**RE: S38 Road Traffic Act 1994,  
Mullinabro Traffic Calming Scheme 2023**

**DATE: 11<sup>th</sup> October 2023**

### **MULLINABRO TRAFFIC CALMING SCHEME 2023**

**Appendix A**  
**Scheme Drawing for Public Consultation**

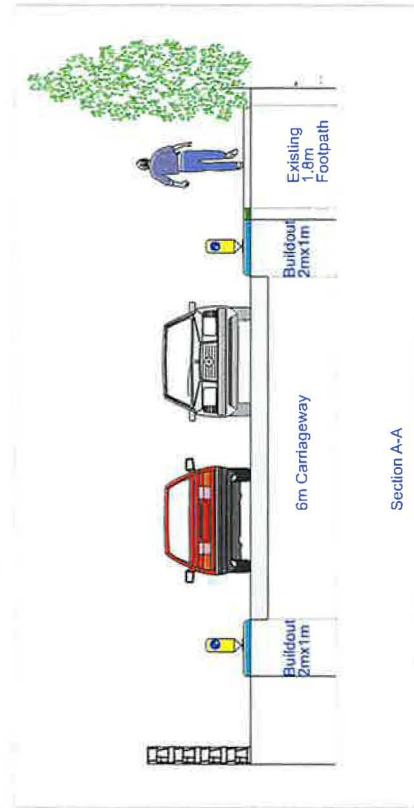
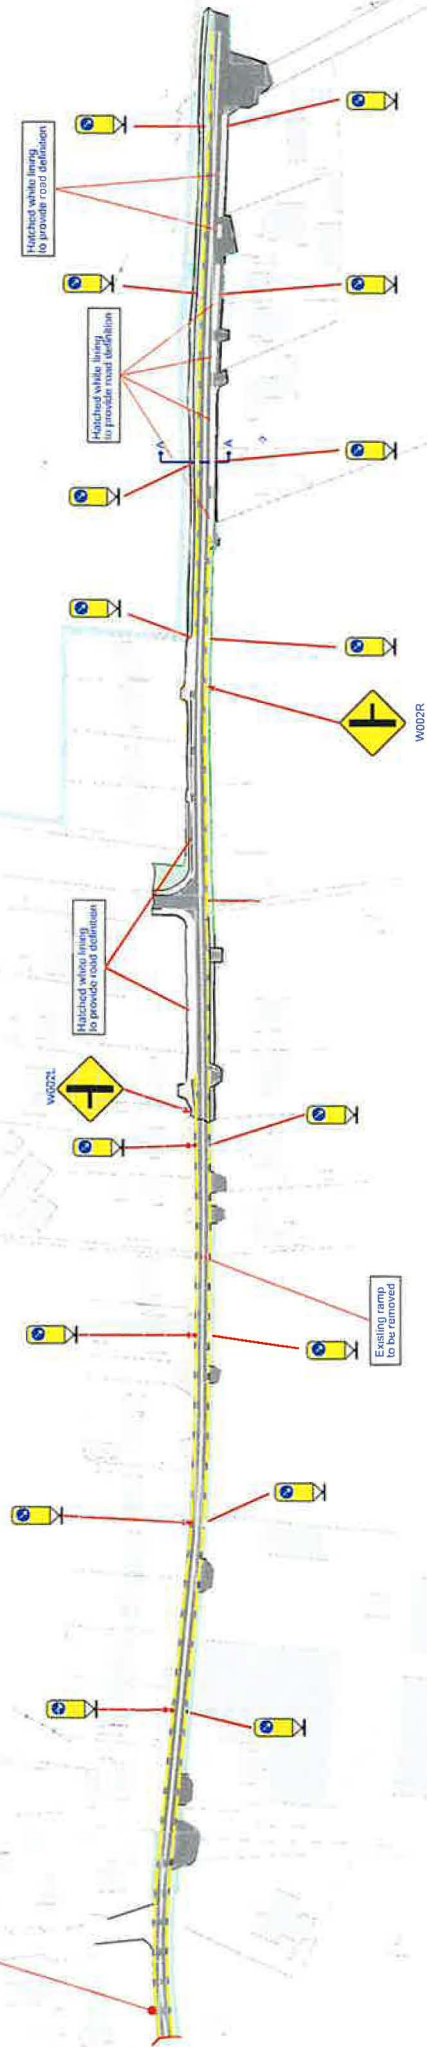
Retain solid centre line, retain existing speed ramp, provide build outs on both sides of the road throughout, extend street lighting

1. The solid white line in the centre of the road should not be removed.
2. The speed ramp at the Cloone Road side of the Mullinabro Road should not be removed because (a) the cost of removing it and reconstituting the road would be money wasted. (b) every possible means should be used on this stretch of road to slow traffic down especially close to the entrance/exit of Mullinabro Woods and outside the houses that front on to the Mullinabro Road.
3. On the town side of the Mullinabro Woods estate entrance/exit there are six outs on the plan to slow traffic down, three on each side of the road opposite each other.

On the Cloone Road side of the Mullinabro Woods estate entrance/exit there are four outs. These outs are only on one side of the road. I believe these outs should be opposite each other and should number six. If only four are to be put in I believe there should be two on each side of the road in a staggered formation as seen in the photo attached. This system works very well in Continental Europe.

The solid white line will be retained to reinforce the efficacy of the traffic calming measures proposed.

The available carriageway width does not provide for full build outs on both sides of the road throughout the scheme. However, smaller buildouts will be provided opposite the build outs on the Cloone Road side of Mullinabro Woods to maintain the narrowing appearance of this part of the road.

- Retain the solid centre line;
- Provide reduced build outs opposite the full-sized build outs on the northern side of Mullinabro Woods;
- Provide advance warning signage for the Mullinabro Woods junction in accordance with the Traffic Signs Manual;
- Provide additional warning signage on Cloone Road following an assessment of suitable signage and locations in accordance with the Traffic Signs Manual.
